Stage 05: Final Modification Report

GC0118:

Mod Title: Modification to the Grid Code to accommodate the recent Distribution Code modification to Engineering Recommendation P28 – *Voltage fluctuations and the connection of disturbing equipment to transmission systems and distribution networks in the United Kingdom.*

Purpose of Modification: The purpose of this modification is to ensure the Grid Code implements the proposed changes as set out in the revised Engineering Recommendation P28 Issue 2 (2018) (subsequently referred to EREC P28 Issue 2).

Figure CC.6.1.7 -
Time and magnitude limits for a category 3 Rapid Voltage Change

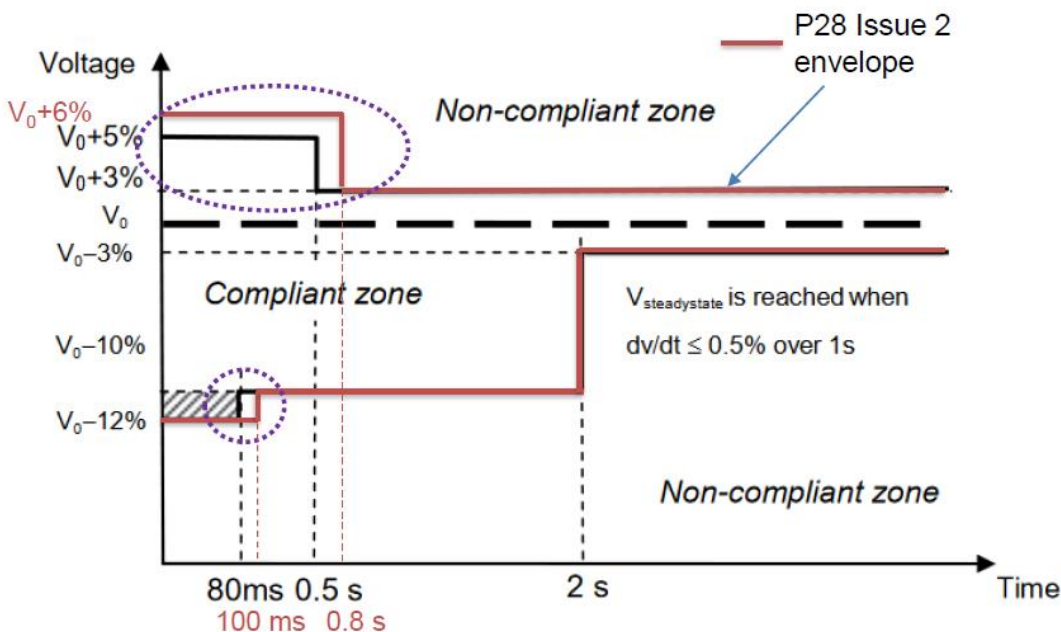
The difference between the voltage envelope for Rapid Voltage Changes in Figure CC.6.1.7 of the Grid Code (the black lines denote the existing requirement) and Table 4 of EREC P28 Issue 2 (the red lines denote the proposed requirement) for Very Infrequent RVCs are shown in the above figure. The Distribution Code Review Panel P28 Working Group has proposed limits for RVC in EREC P28 Issue 2 that:

- generally align with those in Figure CC.6.1.7 of the Grid Code for reductions in voltage.
- are absolute and compatible with EREC G59 and the interface protection requirements for generation connected to distribution systems as well as National Grid's Technical Guidance Note (TGN) 288 for overvoltage.
- are compatible with immunity levels for customer equipment.
- should not result in unacceptable disturbance provided:-
 - events are sufficiently spaced apart.
 - multiple RVCs are completed within a small time window.

Figure CC.6.1.7

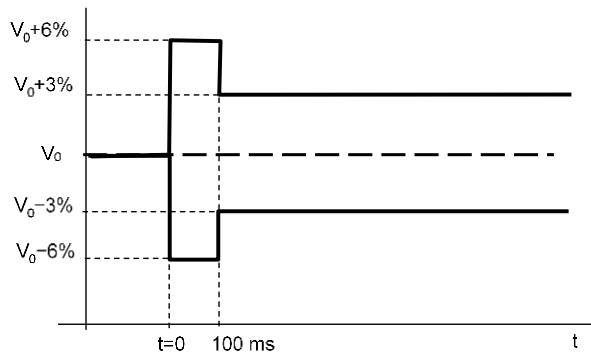
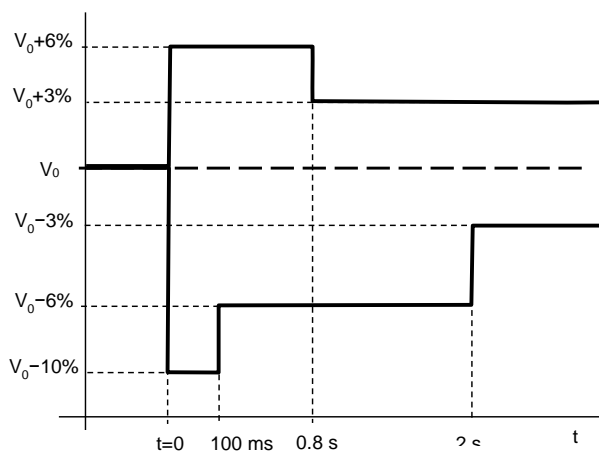
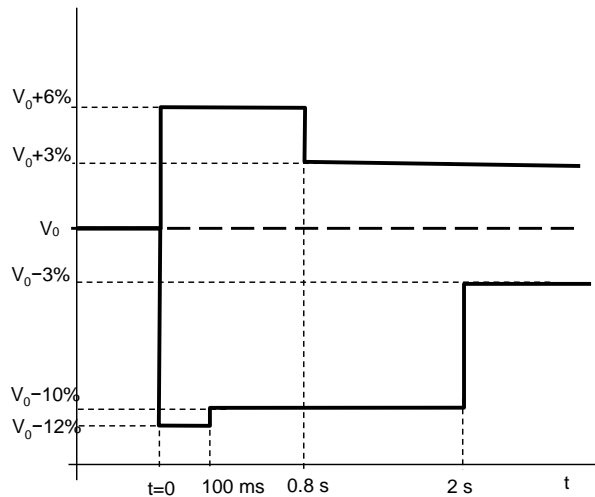
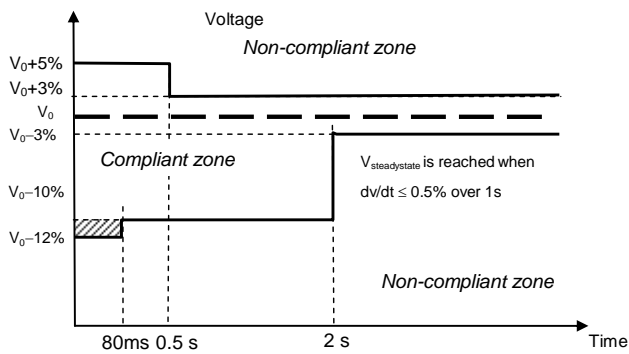
- (c) The RVCs in Category 2 and 3 should not exceed the limits depicted in the time dependent characteristic shown in Figure CC.6.1.7 (2) and Figure CC.6.1.7 (3) respectively. These limits do not apply to: 1) fault clearance operations; or 2) immediate operations in response to fault conditions; or 3) operations relating to post fault system restoration. (for the avoidance of doubt this third exception pertains to a fault that is external to the Users plant and apparatus).

- (d) Any RVCs permitted in Category 2 and Category 3 should be at least 10 minutes apart.
- (e) The value of $V_{\text{steadystate}}$ should be established immediately prior to the start of a RVC. Following a RVC, the voltage should remain within the relevant envelope, as shown in Figures CC.6.1.7 (1), CC.6.1.7 (2), CC.6.1.7 (3), until a $V_{\text{steadystate}}$ condition has been satisfied.

- (f) The voltage change between two steady state voltage conditions should not exceed 3%. (The limit is based on 3% of the nominal voltage of the system (V_n) as measured at the Point of Common Coupling. The step voltage change as measured at the customer's supply terminals or equipment terminals could be greater. For example: The step voltage change limit stated in BS EN 61000-3-3 and BS EN 61000-3-11 is 3.3% when measured at the equipment terminals.)

NOTE 1: $\pm 6\%$ is permissible for 100 ms reduced to $\pm 3\%$ thereafter as per Figure CC.6.1.7 (1). If the profile of repetitive voltage change(s) falls within the envelope given in Figure CC.6.1.7 (1), the assessment of such voltage change(s) shall be undertaken according to the recommendations for assessment of flicker and shall conform to the planning levels provided for flicker. If any part of the voltage change(s) falls outside the envelope given in Figure CC.6.1.7(1), the assessment of such voltage changes, repetitive or not, shall be done according to the guidance and limits for RVCs.

NOTE 3: -10% is permissible for 100 ms reduced to -6% until 2 s then reduced to -3% thereafter as per Figure CC.6.1.7 (2).

NOTE 4: $+6\%$ is permissible for 0.8 s from the instant the event begins then reduced to $+3\%$ thereafter as per Figure CC.6.1.7 (2).

NOTE 5: -12% is permissible for 100 ms reduced to -10% until 2 s then reduced to -3% thereafter as per Figure CC.6.1.7 (3).

NOTE 6: $+6\%$ is permissible for 0.8 s from the instant the event begins then reduced to $+3\%$ thereafter as per Figure CC.6.1.7 (3).

Figure ECC.6.1.7 -

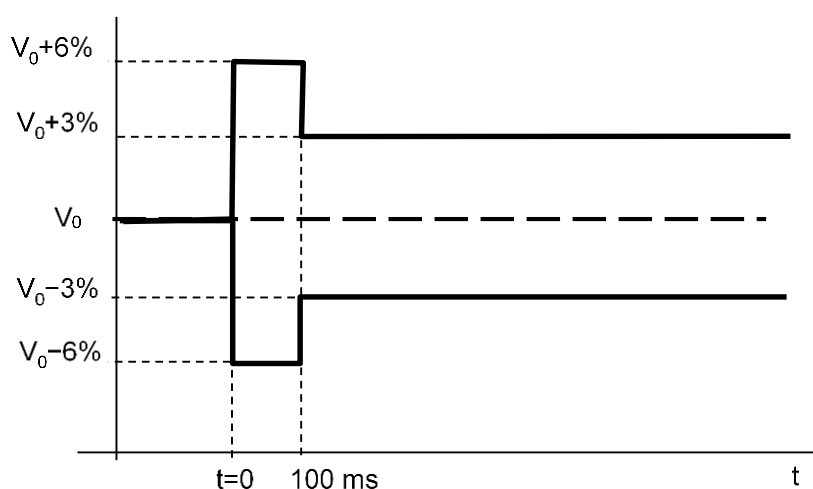
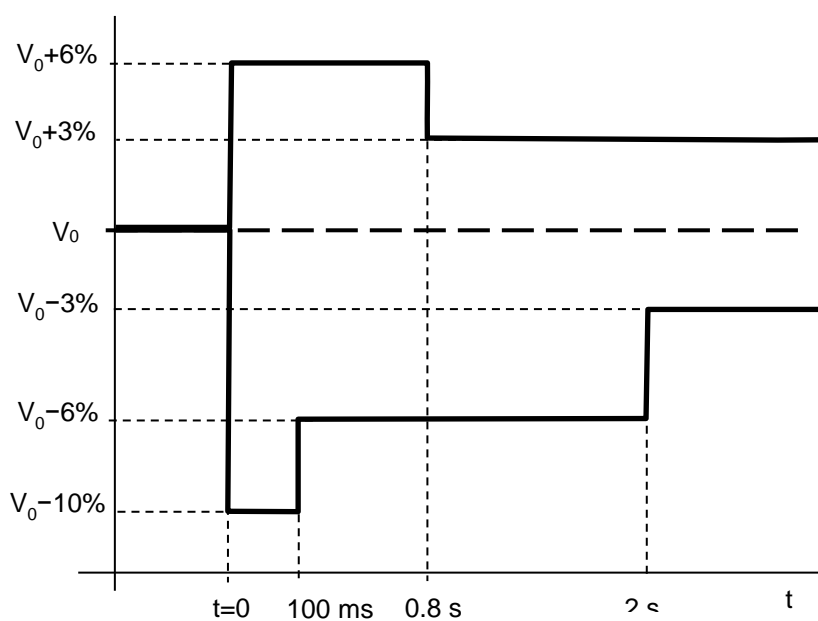
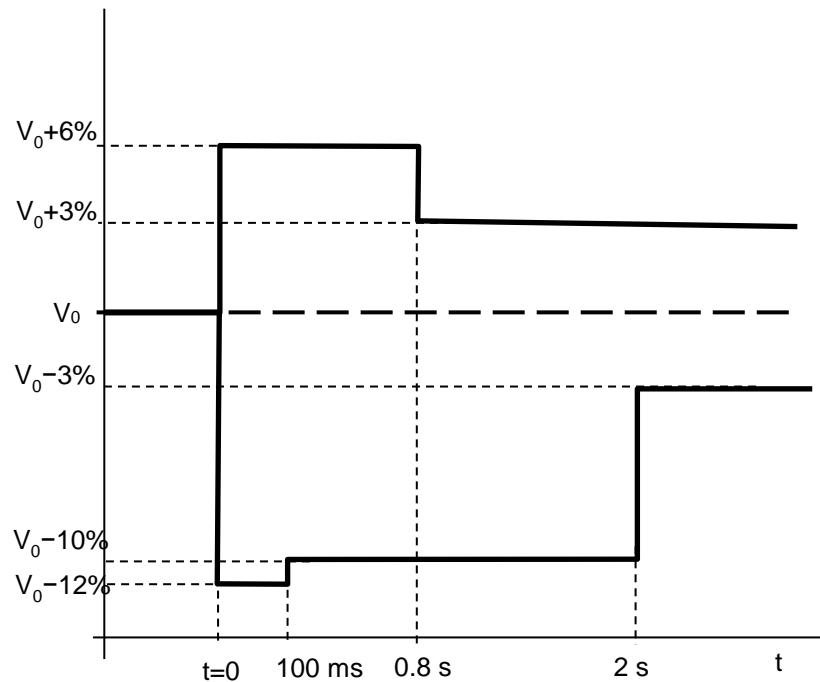
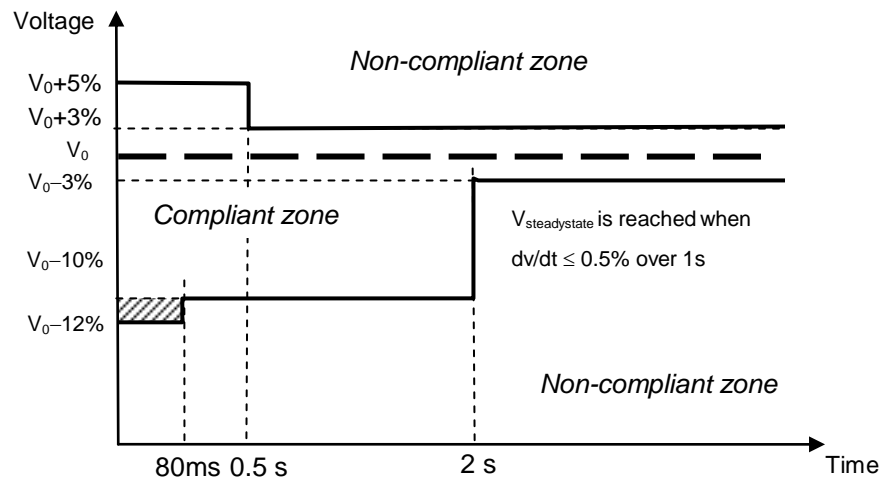
- (c) The RVCs in Category 2 and 3 should not exceed the limits depicted in the time dependent characteristic shown in Figure ECC.6.1.7 (2) and Figure ECC.6.1.7 (3) respectively. These limits do not apply to: 1) fault clearance operations; or 2) immediate operations in response to fault conditions; or 3) operations relating to post fault system restoration (for the avoidance of doubt this third exception pertains to a fault that is external to the **Users** plant and apparatus).

- (d) Any RVCs permitted in Category 2 and Category 3 should be at least 10 minutes apart.
- (e) The value of $V_{\text{steadystate}}$ should be established immediately prior to the start of a RVC. Following a RVC, the voltage should remain within the relevant envelope, as shown in Figures ECC.6.1.7 (1), ECC.6.1.7 (2), ECC.6.1.7 (3), until a $V_{\text{steadystate}}$ condition has been satisfied.

- (f) The voltage change between two steady state voltage conditions should not exceed 3%. (The limit is based on 3% of the nominal voltage of the system (V_n) as measured at the PCC. The step voltage change as measured at the customer's supply terminals or equipment terminals could be greater. For example: The step voltage change limit stated in BS EN 61000-3-3 and BS EN 61000-3-11 is 3.3% when measured at the equipment terminals.)

NOTE 1: $\pm 6\%$ is permissible for 100 ms reduced to $\pm 3\%$ thereafter as per Figure ECC.6.1.7 (1). If the profile of repetitive voltage change(s) falls within the envelope given in Figure ECC.6.1.7 (1), the assessment of such voltage change(s) shall be undertaken according to the recommendations for assessment of flicker and shall conform to the planning levels provided for flicker. If any part of the voltage change(s) falls outside the envelope given in Figure ECC.6.1.7(1), the assessment of such voltage changes, repetitive or not, shall be done according to the guidance and limits for RVCs.

NOTE 3: -10% is permissible for 100 ms reduced to -6% until 2 s then reduced to -3% thereafter as per Figure ECC.6.1.7 (2).

NOTE 4: $+6\%$ is permissible for 0.8 s from the instant the event begins then reduced to $+3\%$ thereafter as per Figure ECC.6.1.7 (2).

NOTE 5: -12% is permissible for 100 ms reduced to -10% until 2 s then reduced to -3% thereafter as per Figure ECC.6.1.7 (3).

NOTE 6: $+6\%$ is permissible for 0.8 s from the instant the event begins then reduced to $+3\%$ thereafter as per Figure ECC.6.1.7 (3).

Figure B.1.2 — $P_{st} = 0.5$ curve for rectangular voltage changes

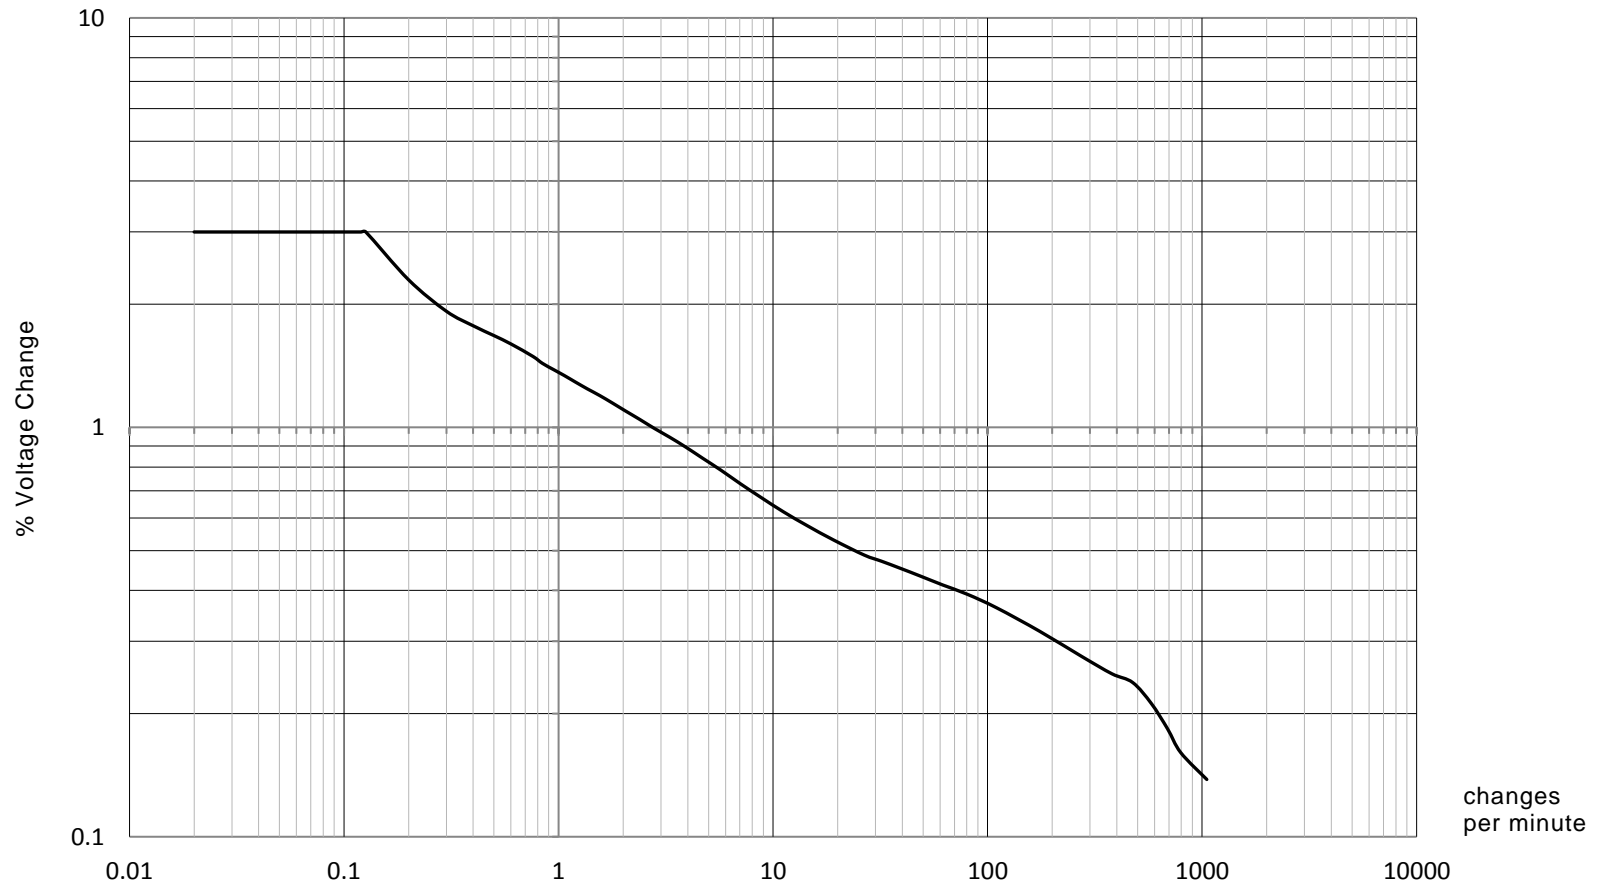
- b) The same respondent also noted there is a reference to current version P28 figure 4 in the SQSS and EREC P28 Issue 2 replaces the original figure 4 with figure B.1.2 and asked for confirmation whether these are the same and whether the SQSS will be corrected?

NOTE 4: Figure B.1.2 replaces Figure 4 in P28 Issue 1.

- i) The Working Group note the acknowledgment in the SQSS that EREC P28 Issue 1 Figure 4 was used in the derivation of Figure 6.1 'Maximum Voltage Step Changes Permitted for Operational Switching'. Figure B.1.2 in EREC P28 Issue 2 is intended to replace Figure 4 in EREC P28 Issue 1 but has been aligned with the current flicker severity curve in Figure A.1 of PD IEC/TR 61000-3-7 – except that the curve has been deliberately capped at a maximum symmetrical step voltage change of 3% once every 475 s. Consequently, the curve in Figure B.1.2 in EREC P28 Issue 2 differs from that in Figure 4 of EREC P28 Issue 1 and Figure 6.1 of the SQSS. The P28 Working Group recommend that Figure 6.1 in the SQSS is reviewed in light of the current flicker severity curve in Figure A.1 of PD IEC/TR 61000-3-7 and the aligned Figure B.1.2 in EREC P28 Issue 2.

Figure 5 — Voltage characteristic for frequent events (Category 1)

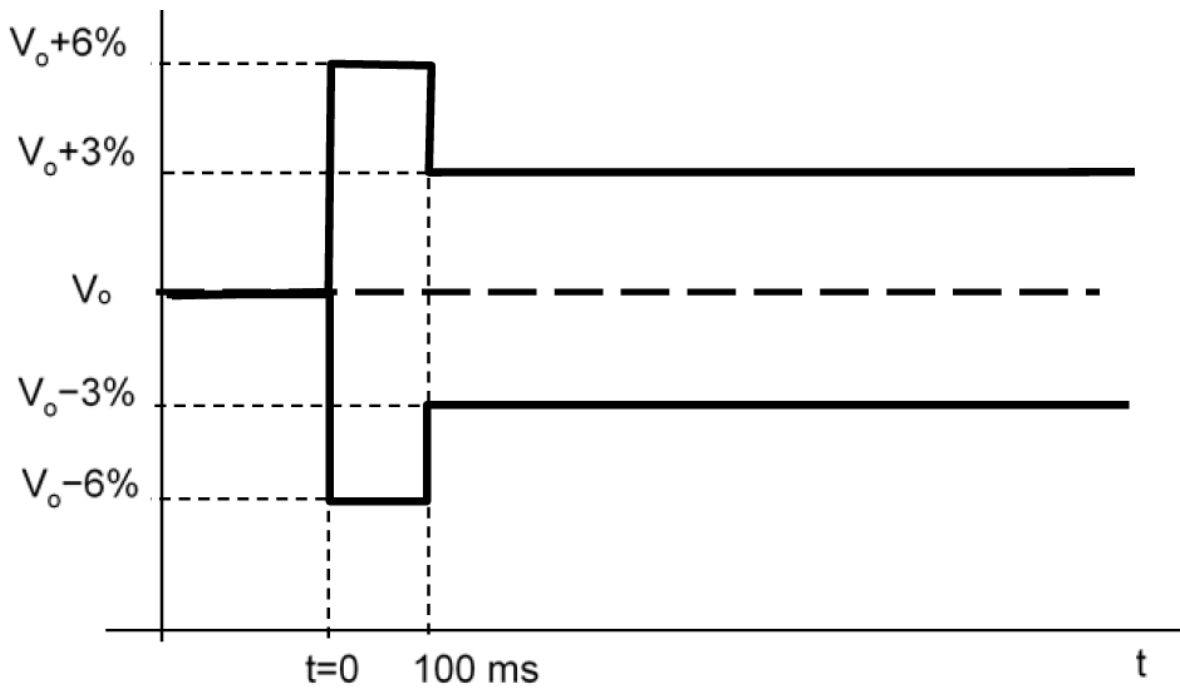
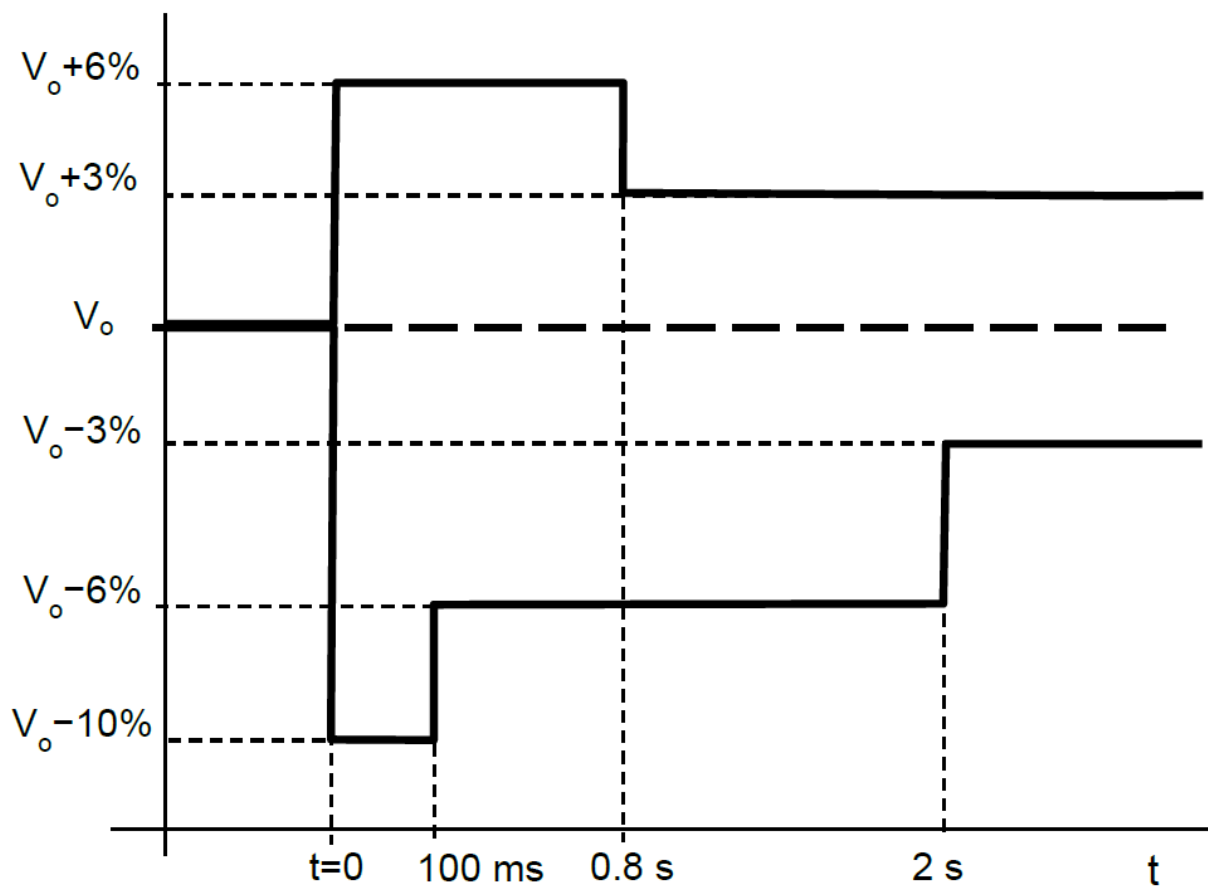
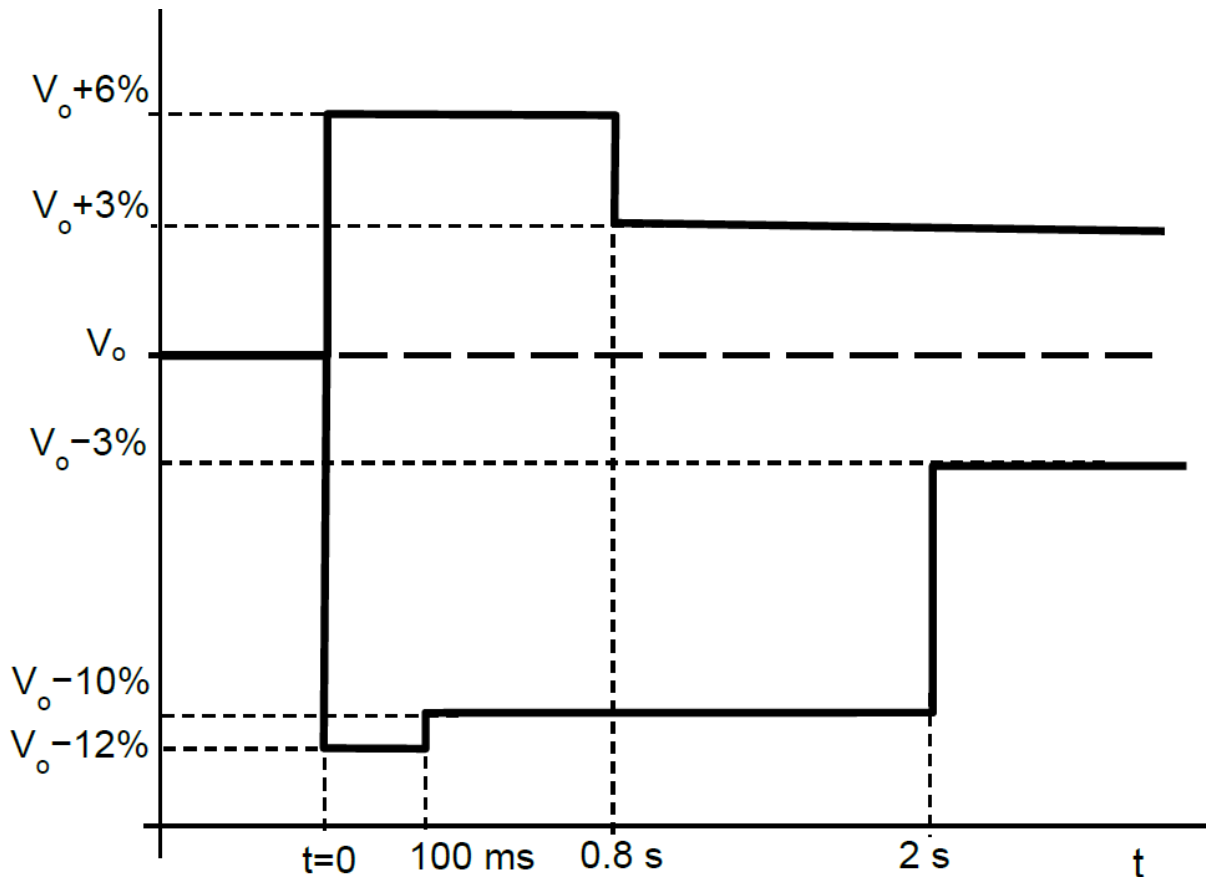
- 5.6 However, two of the respondents provided extensive comments in relation to the proposed requirements and planning levels for RVCs as provided in Figure 5, Figure

6, Figure 7 and Table 4 of EREC P28 Issue 2 (see Question 1). The responses to Question 1 related to the following.

i) In response, the Working Group do not believe the requirements in EREC P28 Issue 2 are more onerous than Category 2 of Grid Code CC.6.1.7. The time and voltage magnitude limits for Category 3 RVCs shown in Figure CC.6.1.7 of the Grid Code when compared with Figure 7 of EREC P28 Issue 2 confirm that both the time and voltage limits in EREC P28 Issue 2 for Category 3 very infrequent events (not more than 4 RVCs in 1 day providing less frequent than once every 3 calendar months) are less onerous than those for Category 3 RVCs in the Grid Code.

4.2.11 The minimum interval between frequent events fitting within the envelope in Figure 5 is determined by conformance to flicker severity (P_{st}) limits in EREC P28 Issue 2.

4.2.12 Up to 4 RVC events per calendar month are permitted for voltage fluctuations fitting within the envelope in Figure 6.

- EREC P28 Issue 2 introduces an intermediate category of RVC (Category 2) for 'infrequent events', where up to a maximum of 4 RVCs in one day are permitted not more frequent than 4 times per month providing the $\Delta V_{\max} \leq -10\%$ for ≤ 100 ms then reducing to $\leq 6\%$ for up to 2 s after initiation of the event (see Figure 6).
